Final Drainage Report: Outlook Powers & Grinnell

EPC STORMWATER REVIEW COMMENTS
IN ORANGE BOXES WITH BLACK TEXT

Harris Kocher Smith Project No. 221206

Engineering Profile - Stormline B (Powers & Grinnell StormCAD.stsw)

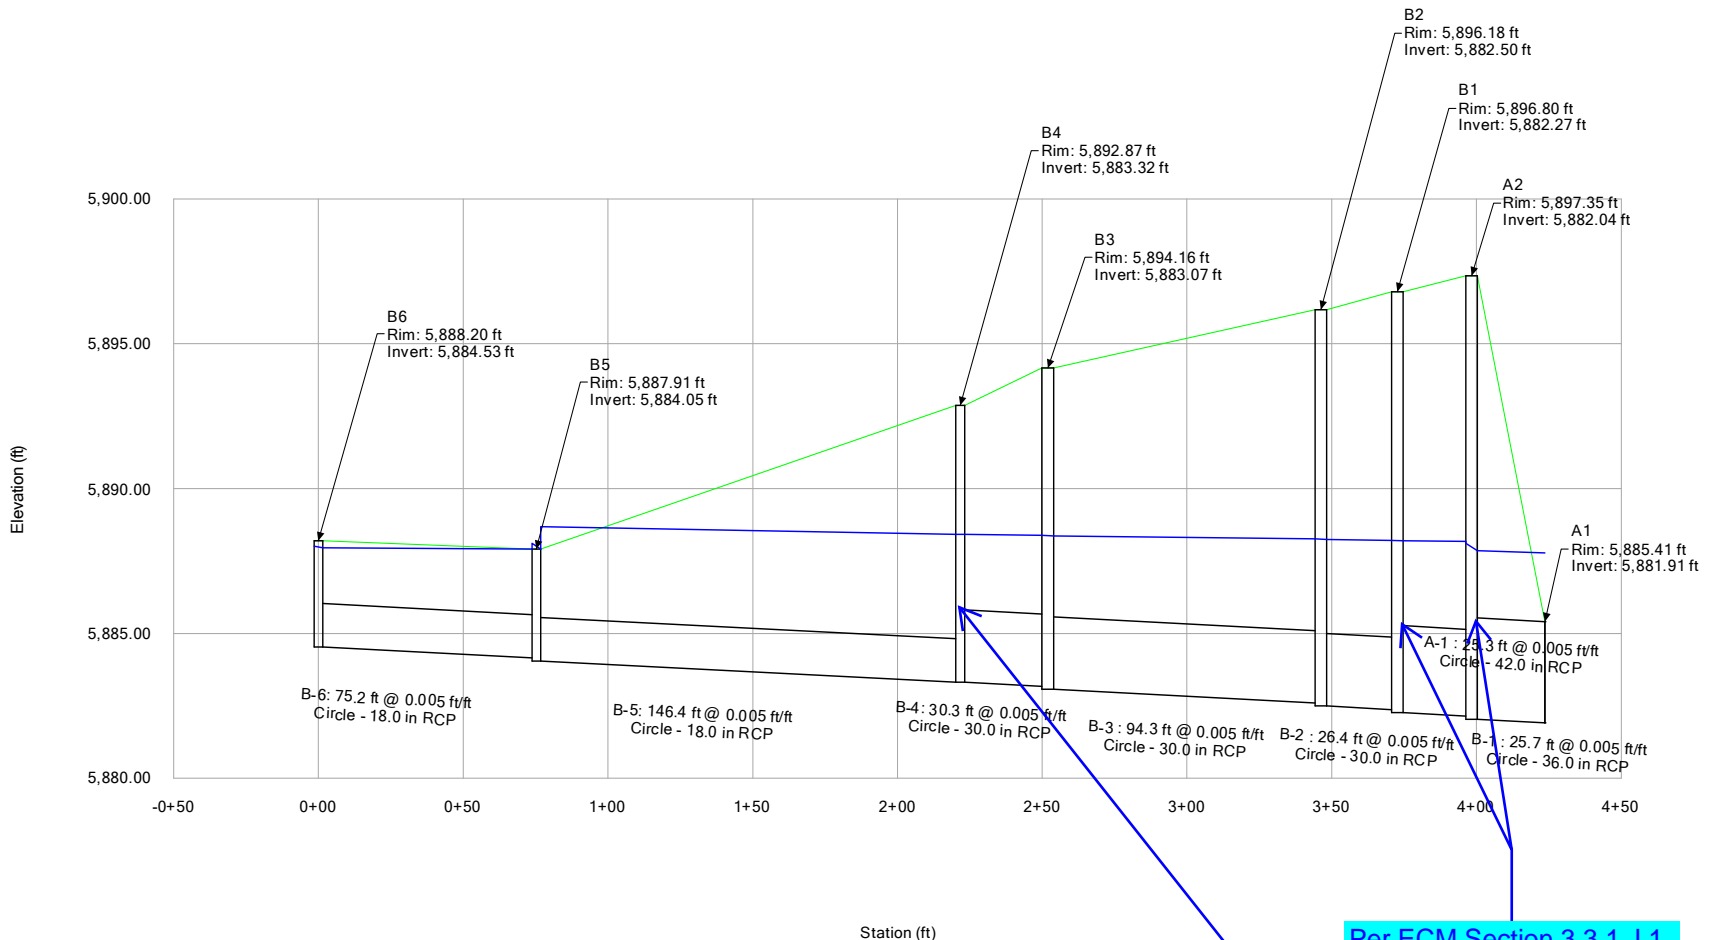
Per ECM Section 3.3.1.J.1, where conduit size increases, inside top slopes of conduit shall be continuous in elevation

Engineering Profile - Stormline V (Powers & Grinnell StormCAD.stsw)

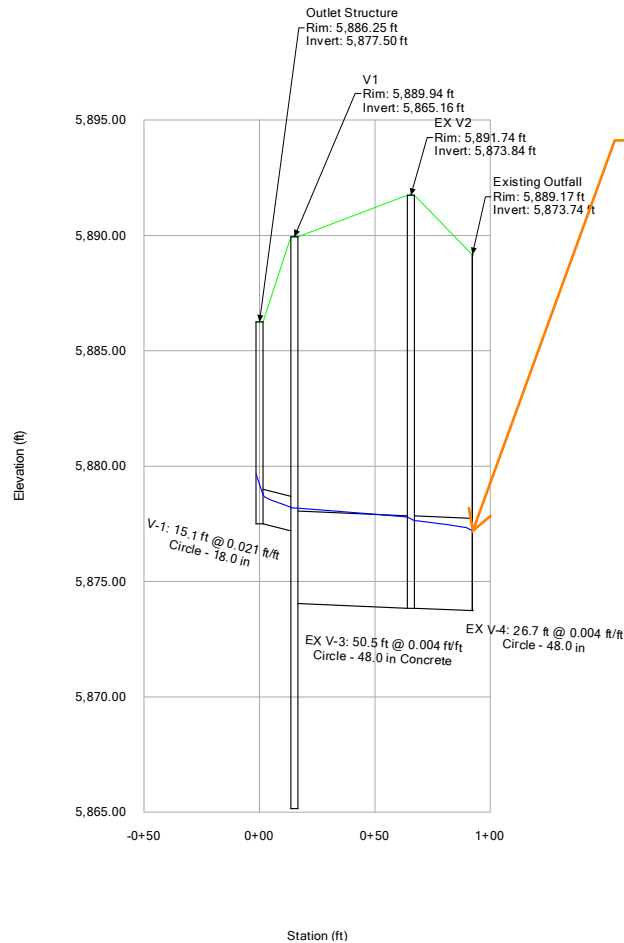
What is the tailwater here? The HGL lowers at the outlet and with large flows and multiple pipes outletting at this location I would anticipate significant tailwater which could effect the pipe sizing. Verify.

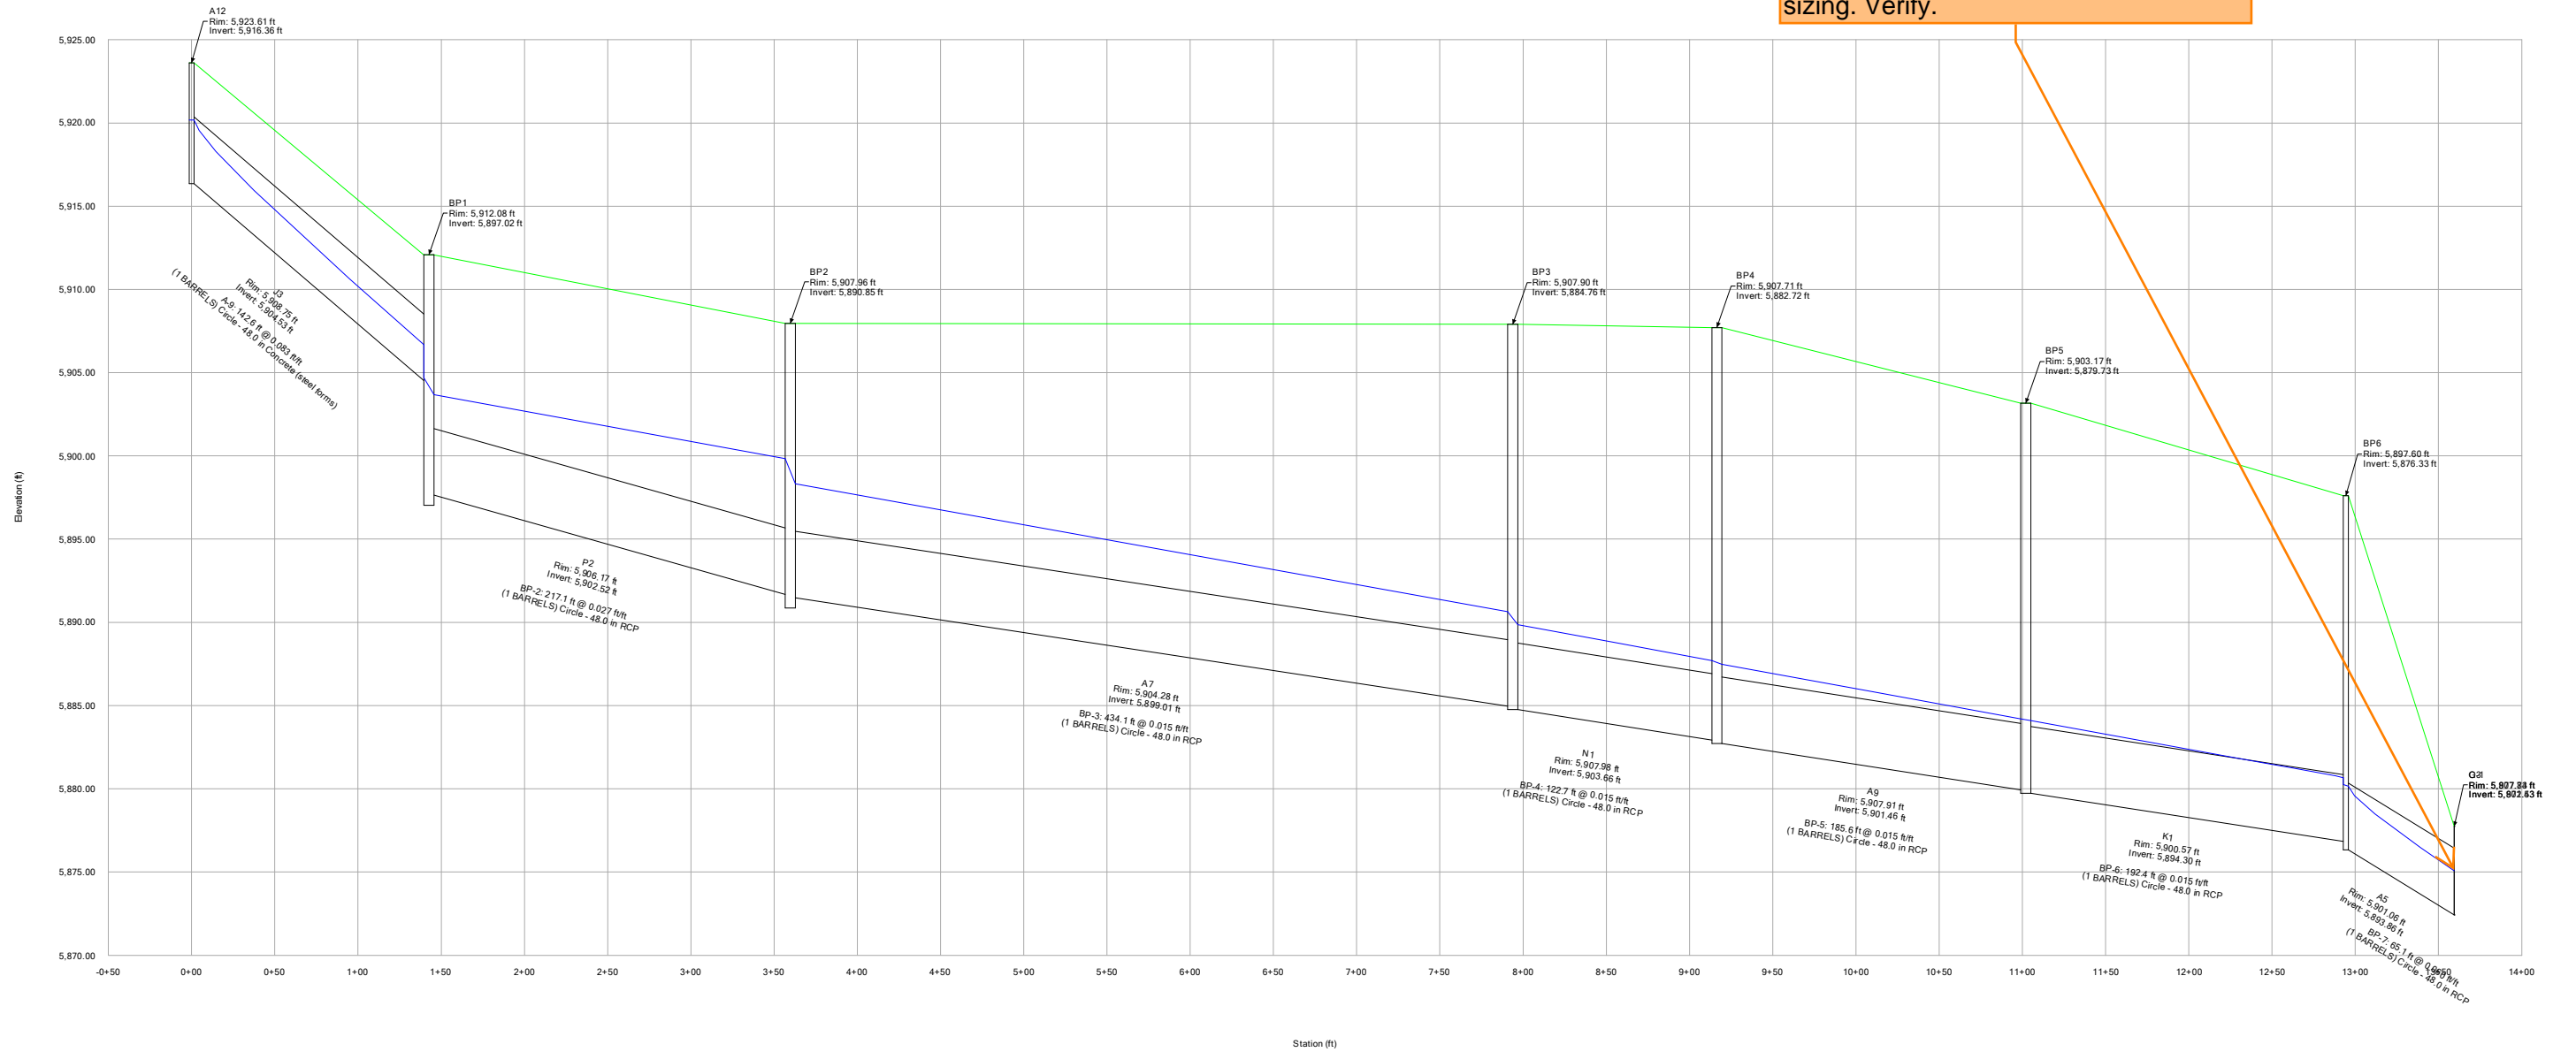
Per ECM Section 3.3.1.J.8 max velocity in storm sewer is 18 fps. Please revise to meet max velocity constraint

Add a note providing the source of the flow.

The pipes are above capacity for these four segments.

This is a very high velocity - provide outlet protection and calculations.

What is the tailwater here? The HGL lowers at the outlet and with large flows and multiple pipes outletting at this location I would anticipate significant tailwater which could effect the pipe sizing. Verify.

DETENTION BASIN STAGE-STORAGE TABLE BUILDER

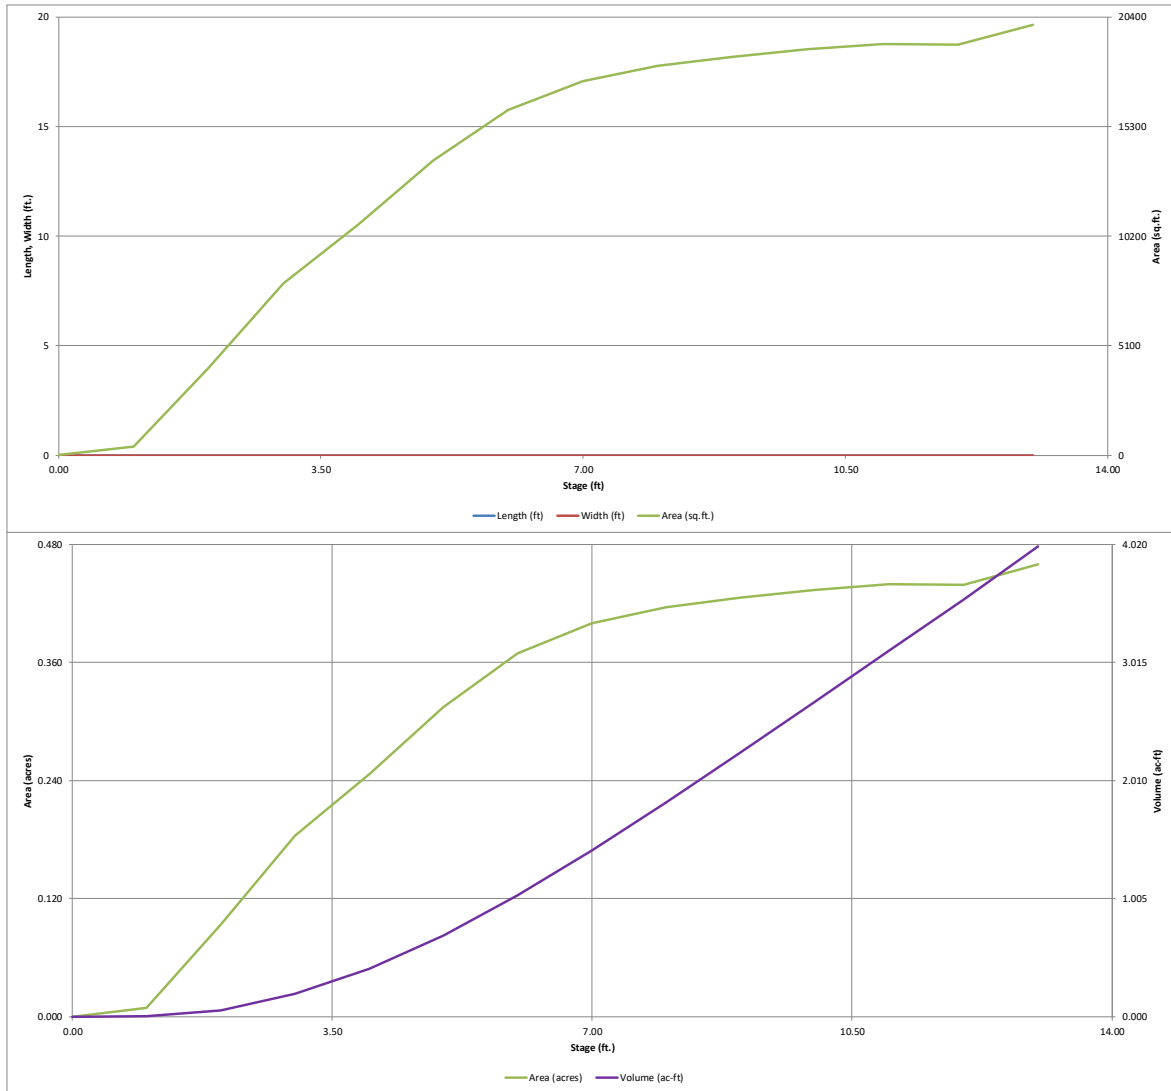
Verify all values and update so the Spreadsheet and Pond Details in the CDs match.

None of the orifices are 1-1/16 in and all three are different per the CDs. Verify and update so both match.

This is not shown on the orifice plate detail in the CDs.

OUTLOOK POWERS & GRINNELL
EXISTING DRAINAGE PLAN

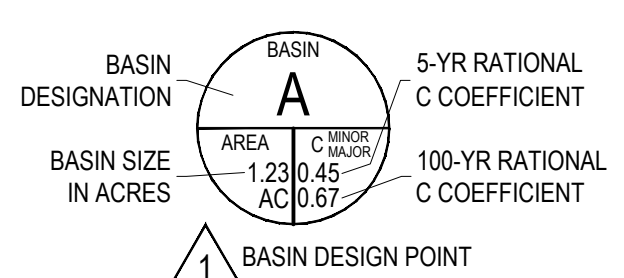
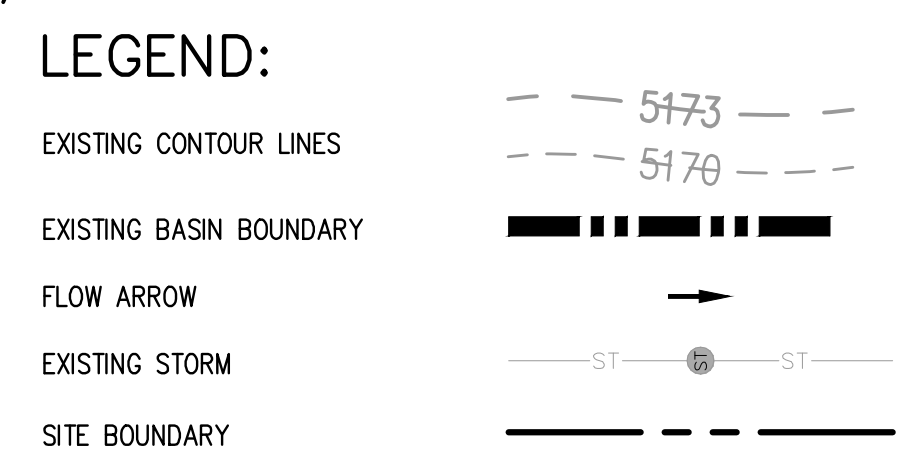
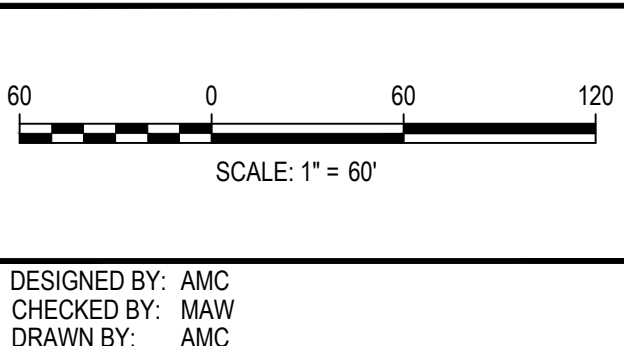
Move drainage plans to the end of the report

Show time of concentration paths

Sub-basin is missing label. Please revise and account for in report.

Show and label 8'x6' culvert

Show existing RCP as it is not shown.

Show and label gravel road denoted in historic composite-C spreadsheet in Appendix C

Show and label existing corrugated pipes in the channel. Mark as to be removed or remain.

Show and label existing channel boundaries caused by erosion

Show the current condition contours - the flows from the box culvert has eroded the surface here 10'-20'

Show existing riprap inside of the channel.

Show limits of pond and offsite grading

Add "PCD File No. SF2318"

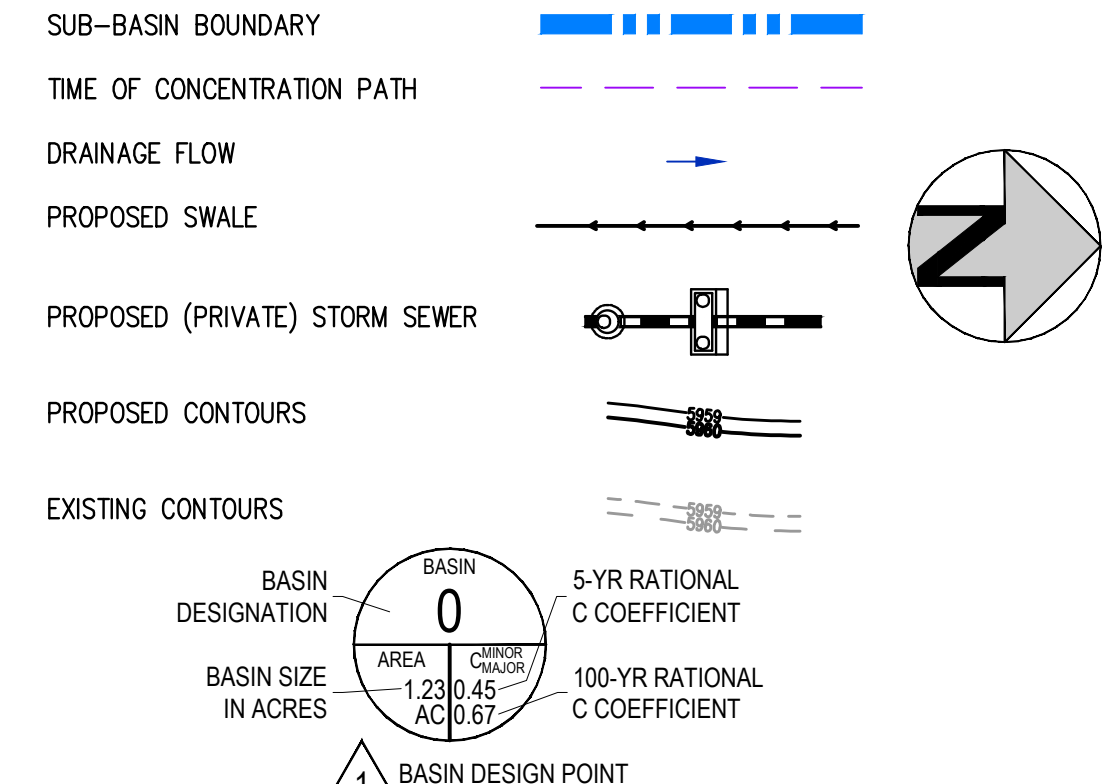
Recommend adding broken down drainage plan with matchlines for better detail clarity and readability.

The callout for this RCP is existing but it is solid and not greyed out - clarify and provide legend for storm sewer lines to clearly show what is existing and what is proposed.

Drainage text says 2.12, verify and update so both match.

Is this segment of pipe going to stay existing and the rest is replaced? Show a legend so it is

Add a design point at the ultimate outfall. Flows at this location must be less than the "Existing Drainage Plan" Design Point 1.

Add hatching to legend

Label Street
